Access Compliance Report Public Rights-of-Way (Curb Ramps)

Intersection ID: 11963 Main Street: S_GRAHAM_ST Cross Street: W_4TH_ST Location: W

ADA ID: 77A2AC3F1090 Ramp Type: Combination1 Initial Pass/Fail: Fail Overall Compliance: No Severity Score: 22.5

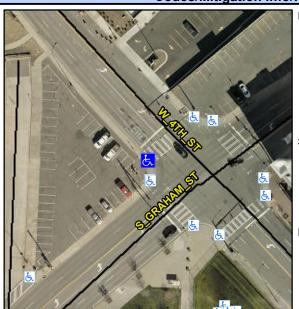
N/A Ramp Length LT (in)
No Ramp Width LT (in)
No Ramp Slope LT (%)
Yes Ramp XSlope LT (%)
N/A Ramp Length (in)
Yes Ramp Width (in)
Yes Ramp Width (in)

R304.5.1, R304.5.3, R304.3.2

Remove & Replace Entire Ramp.
